MFN 07-479
September 4, 2007

Subject: **Submittal of ABWR Licensing Topical Report (LTR) NEDO-33372,
"Advanced Boiling Water Reactor (ABWR) Containment Analysis"**

Enclosure: NEDO-33372 "Advanced Boiling Water Reactor (ABWR)
Containment Analysis", September 2007 – Non-Proprietary

**Figure 4 Revised Feedwater Line Break Flow –
Feedwater System Side of Break**

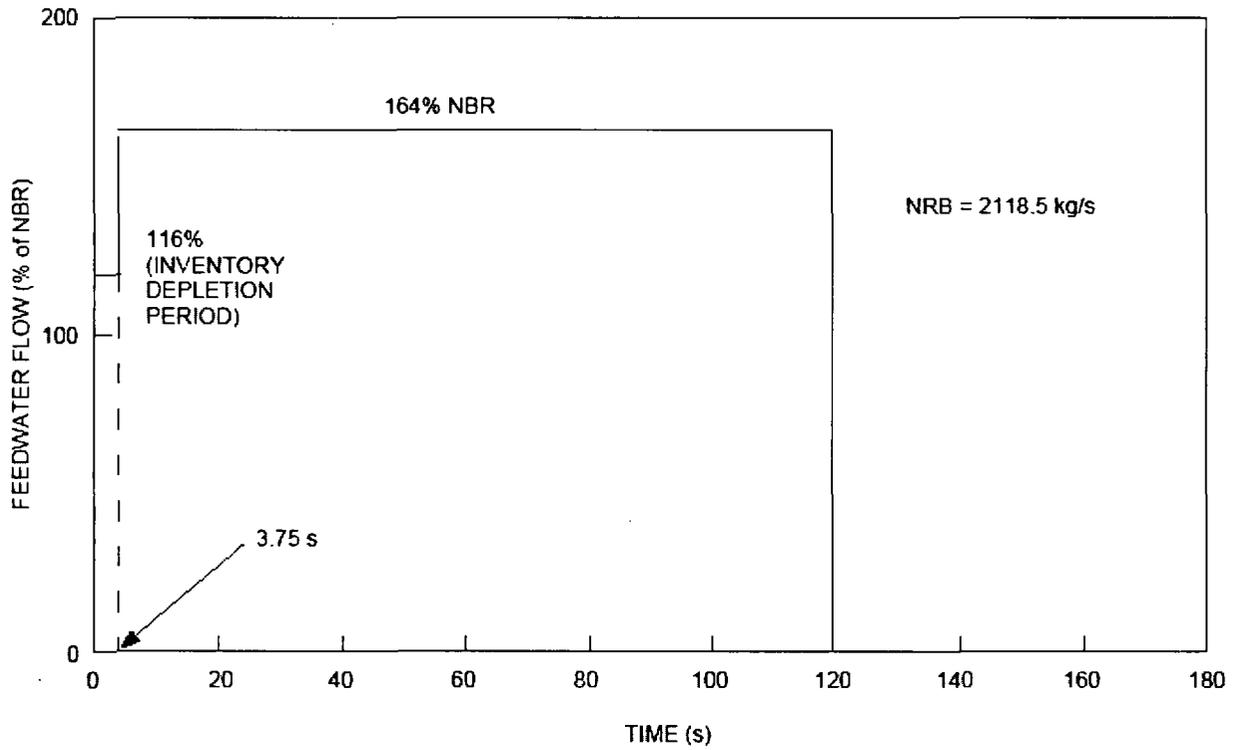
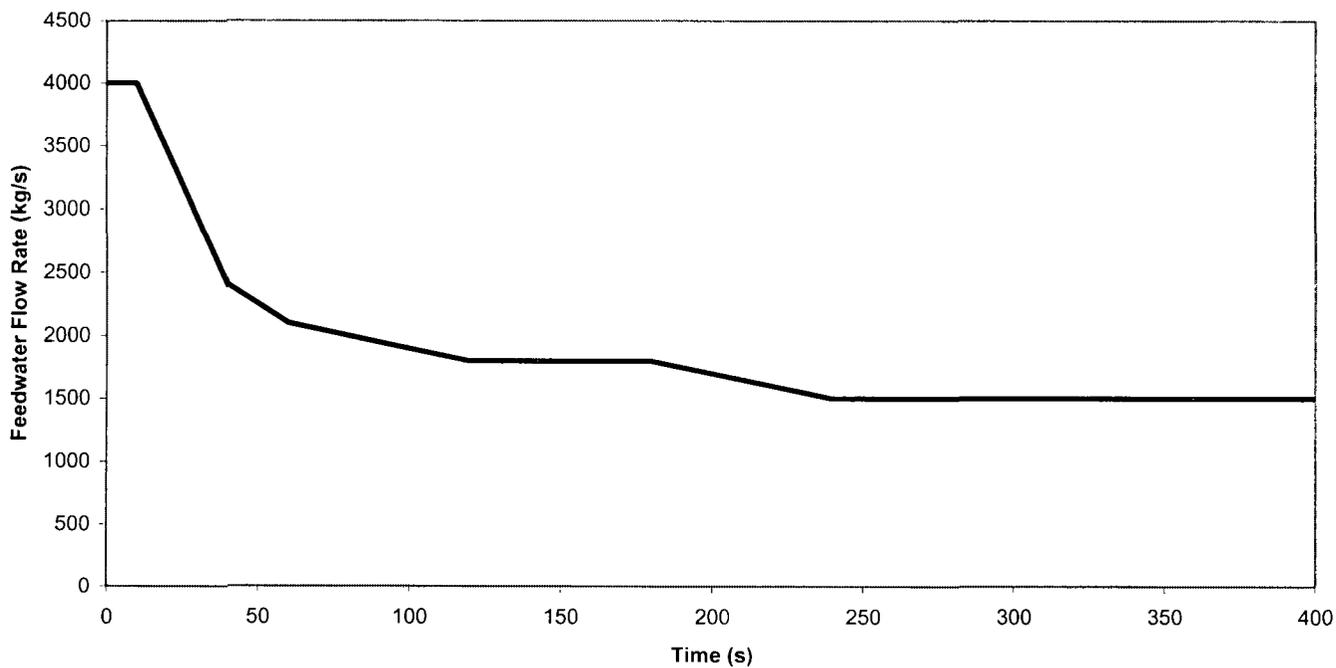
The feedwater system side of the FWLB was again modeled (Figure 4) by using a revised time variant feedwater mass flow rate and enthalpy directly to the drywell airspace. As shown in this figure, however, flow is assumed to continue until the condensate discharge and feedwater portions of the systems are drained. This eliminates the certified ABWR DCD baseline assumption of feedwater flow step changing to zero at 120 seconds. The time histories of the mass flow and enthalpy (Figure 5) were determined from the predicted characteristics of a typical feedwater system performance. The conservatism of the assumed mass flow and enthalpies will be confirmed after the detailed condensate and feedwater system designs and procurement of major equipment are completed (e.g., piping lengths and pump characteristics).

Figure 6 Feedwater Line Break Mitigation

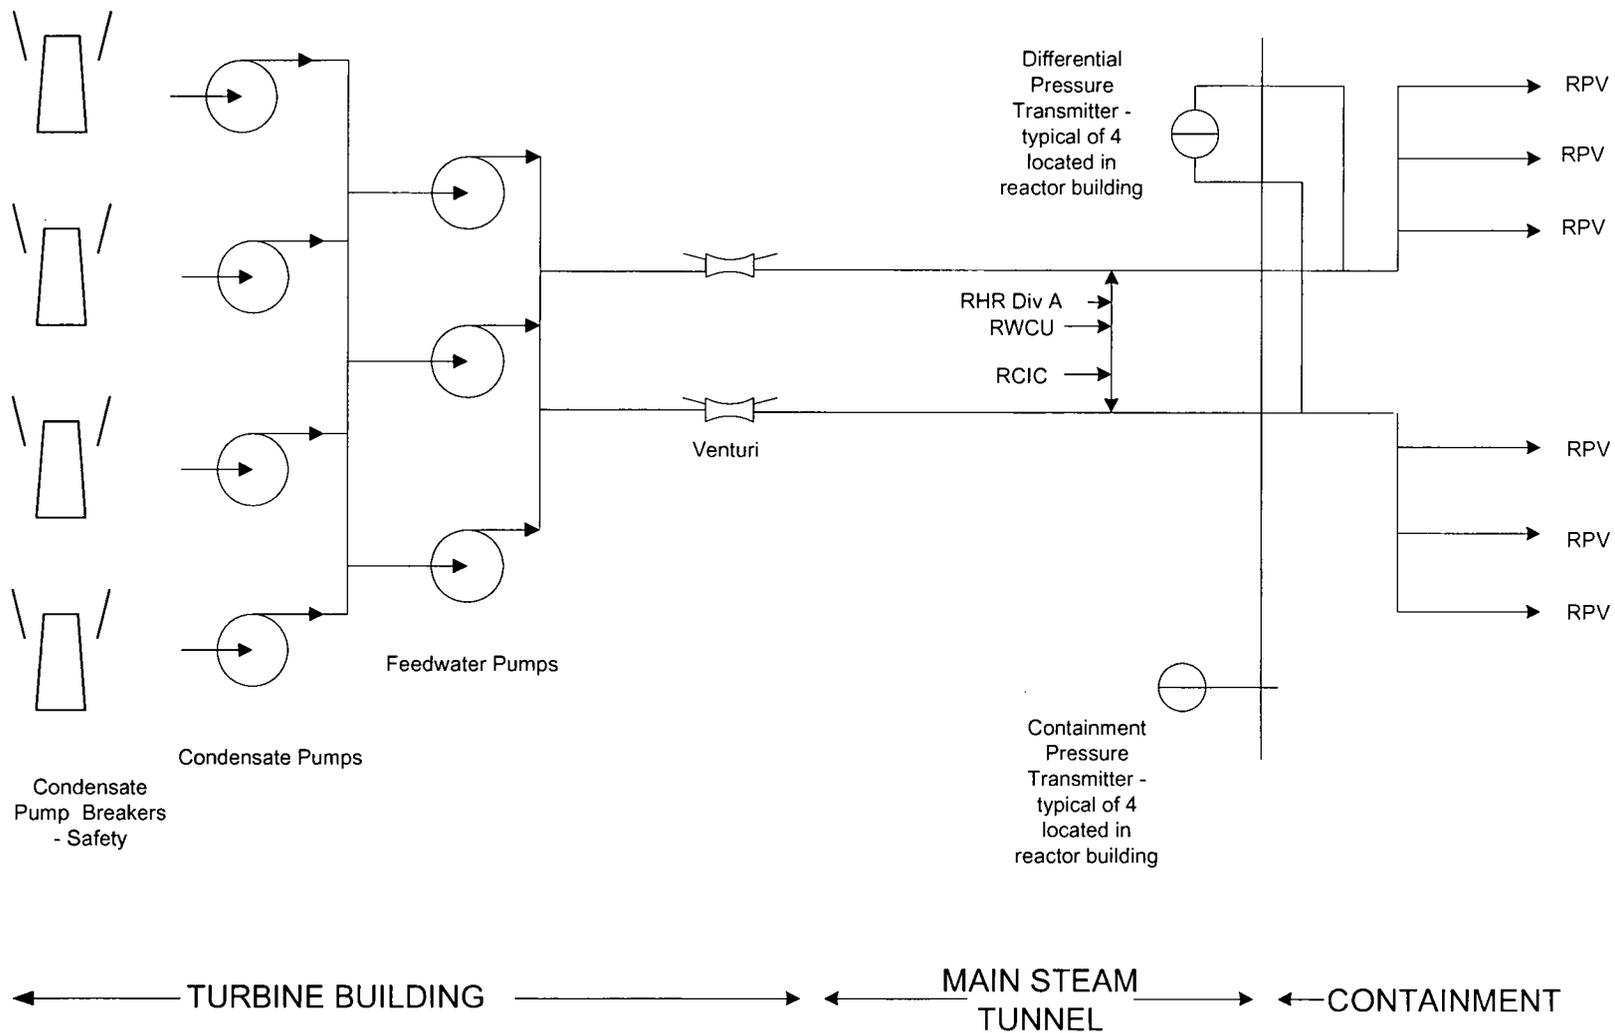
In addition, to provide added assurance of acceptable results, FWLB mitigation is added to the ABWR design. A break of the feedwater line is detected by instrumentation that measures the differential pressure between the two-feedwater lines and then confirmation of high drywell pressure will enable the logic to trip the condensate pumps (Figure 6). The logic and breakers will be safety-related to add assurance that only safety-related equipment is credited in the analysis.

Figure 3B-13 Schematic of the Pool Swell Phenomenon

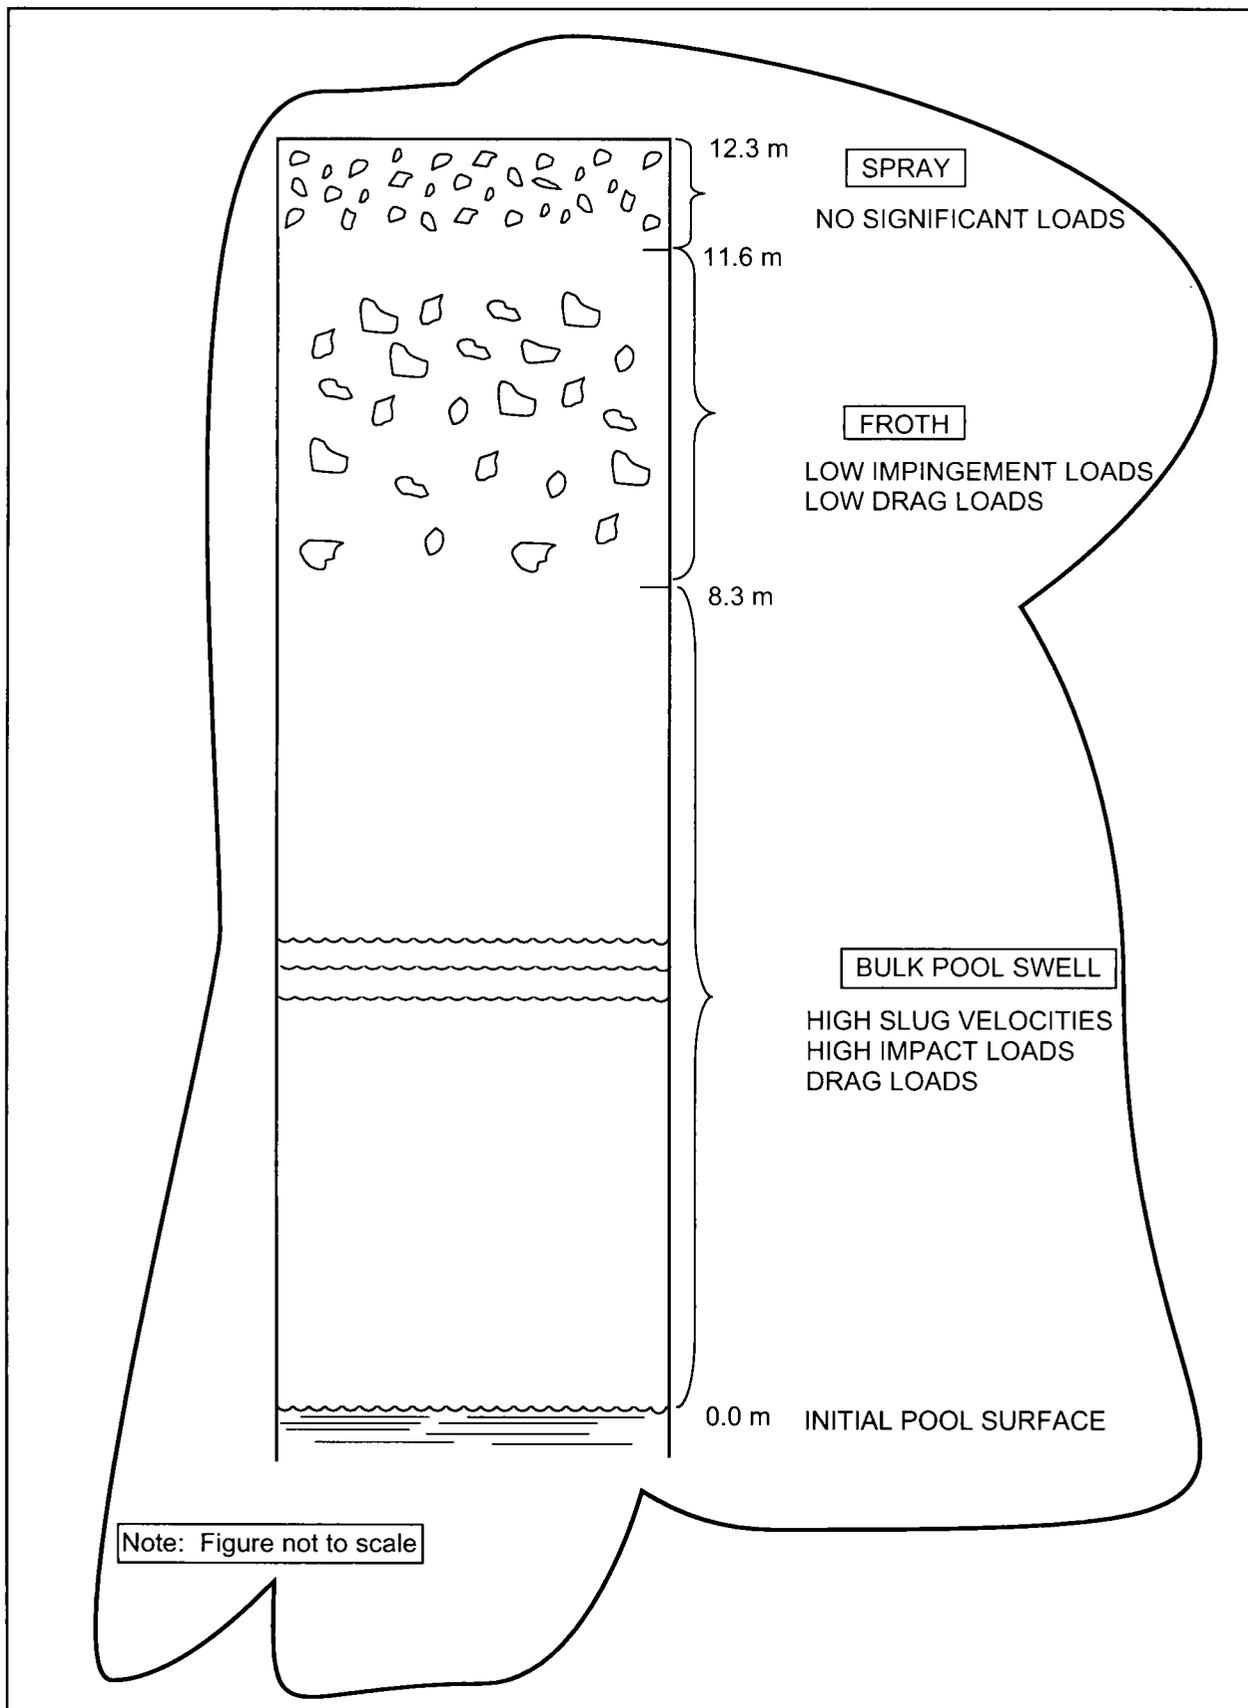
As shown in Figure 3B-13 the gas space above the ~~10.3m~~ 11.6m elevation will be exposed to spray condition ~~including~~, which is expected to induce no significant loads on structures in that region.

Figure 6.2- 8a Pressure Time History After a Feedwater Line Break

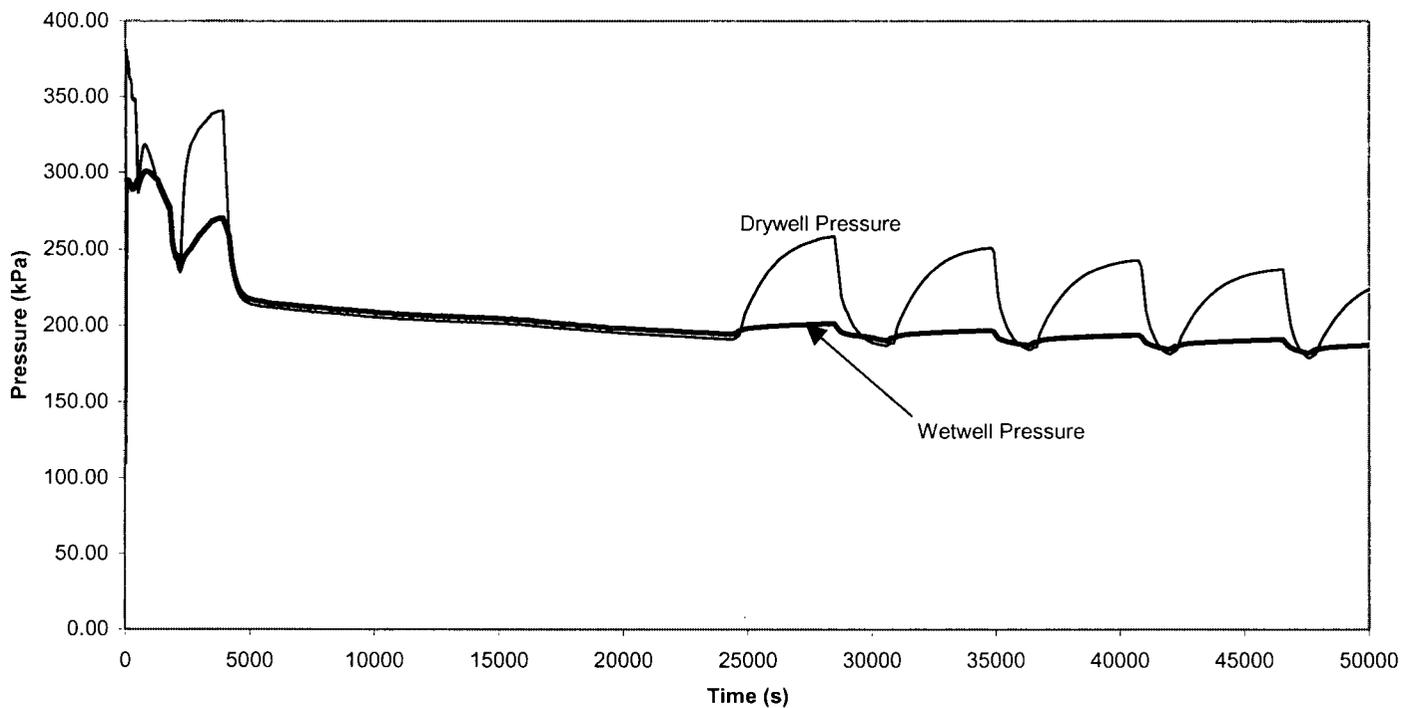
The ~~short~~ long-term pressure peak (~~268.7~~ 279.6 kPaG) of Figure 6.2-8a is the peak pressure for the whole transient. Figure 6.2-8 shows temperature time histories for the suppression pool, wetwell, and drywell temperatures. The peak pool temperature (~~96.9~~ 97.1 °C) is reached at ~~15,350~~ 8596 seconds (~~4.264~~ 2.39 hours) and remains below the 97.2°C limit.

Figure 6.2- 24 Break Flow Rate and Specific Enthalpy for the Main Steamline Break with Two-Phase Blowdown Starting When the Collapsed Water Level Reaches the Steam Nozzle

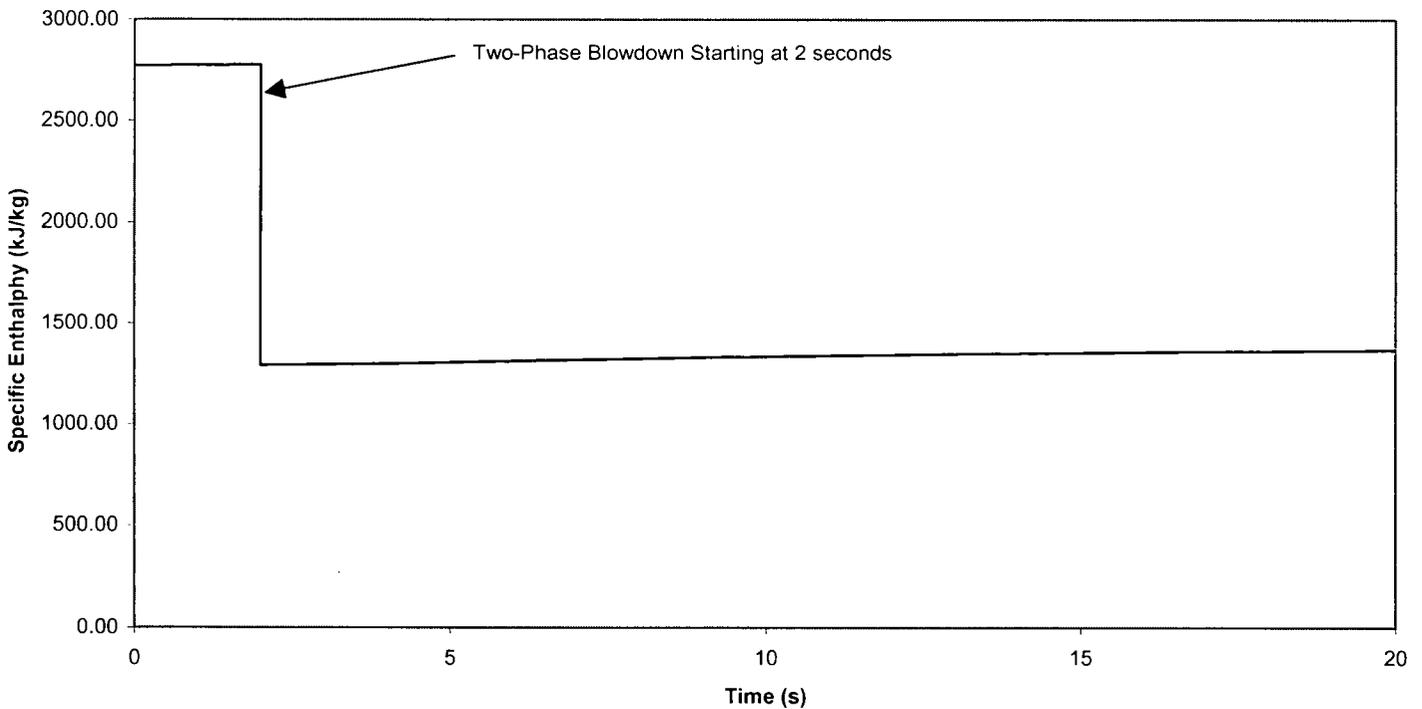
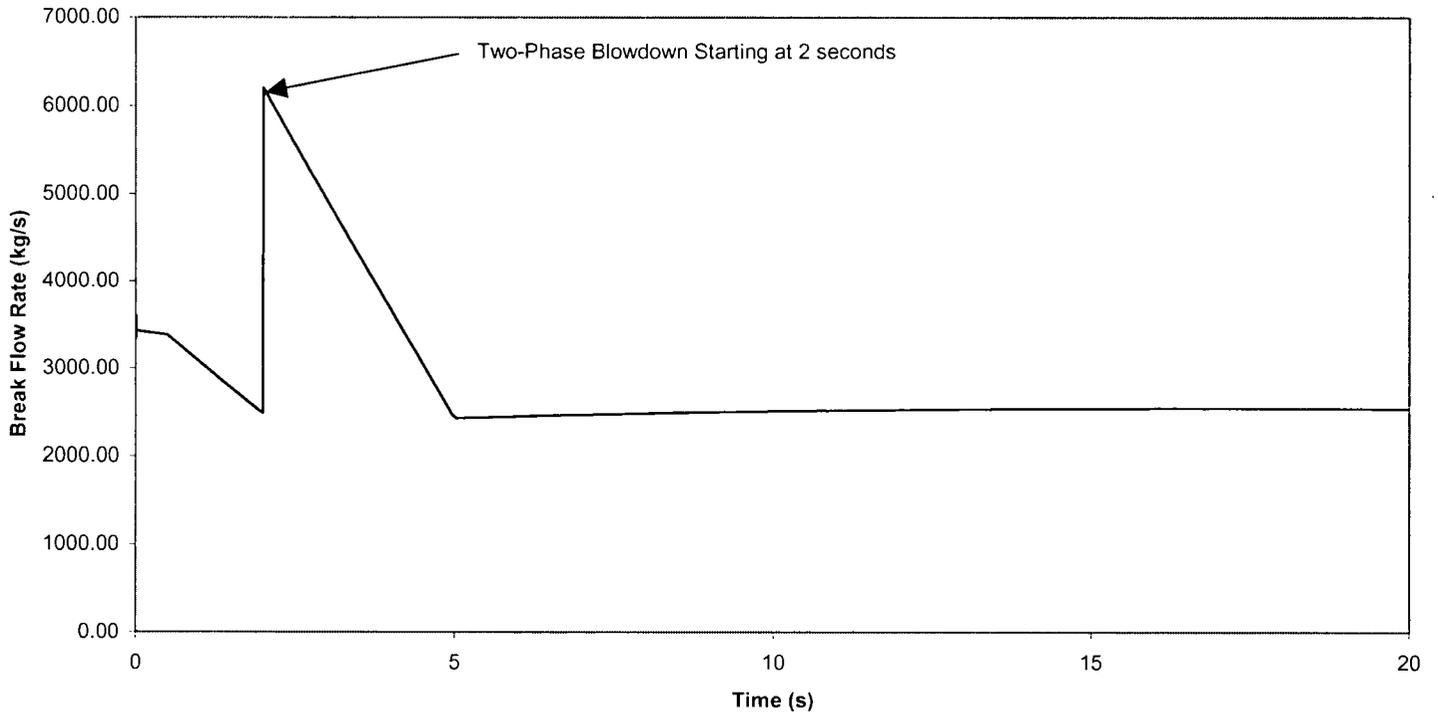
Delete Figure Not Used

**~~Figure 6.2-25 Break Flow Rate and Specific Enthalpy for the Main Steamline
Break with Two Phase Blowdown Starting at One Second~~**
